May 2, 2003  
NG-03-0304

Subject: Duane Arnold Energy Center  
Docket No: 50-331  
Op. License No: DPR-49  
Revision of Technical Specification Change Request (TSCR-059A): "Update to Reactor Coolant System Pressure and Temperature Limit Curves."

Proposed Change TSCR-059A to the Duane Arnold Energy Center  
Technical Specifications

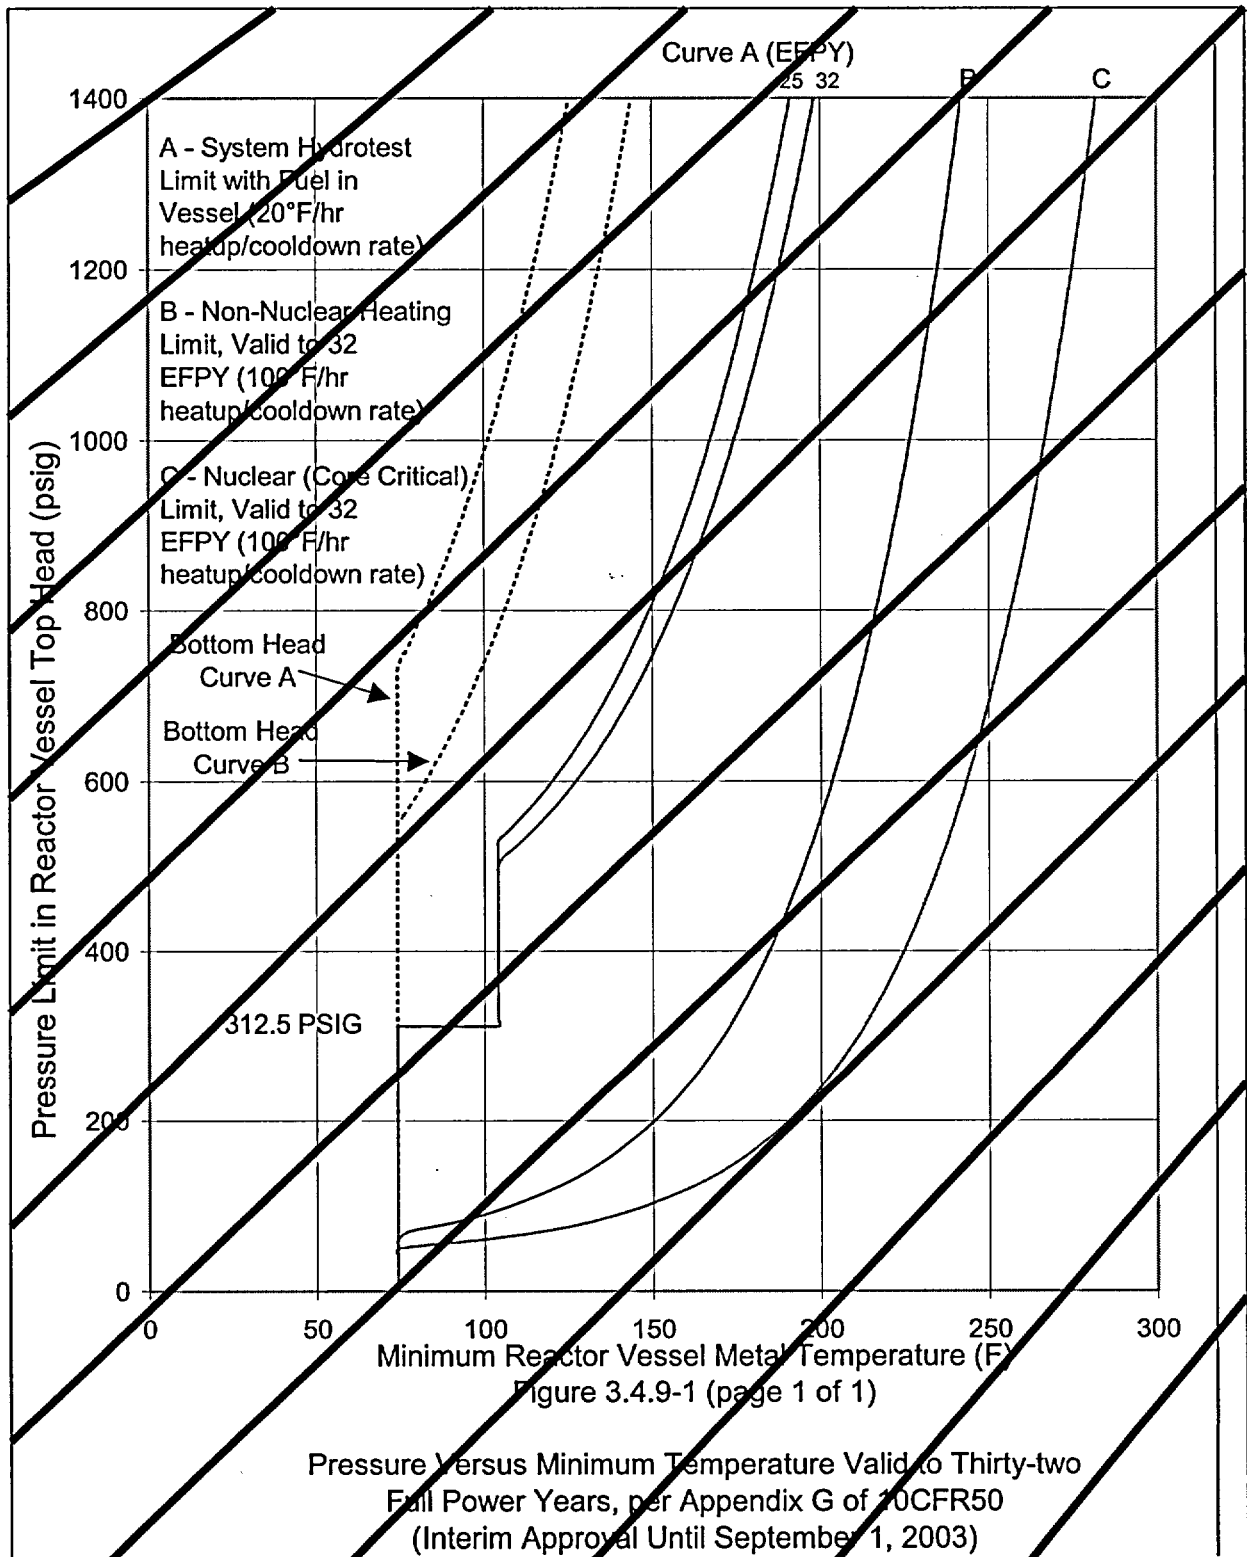
<u>Page</u>	<u>Description of Change</u>
3.4-24	Replace existing Figure 3.4.9-1 with the new Figure 3.4.9-1.
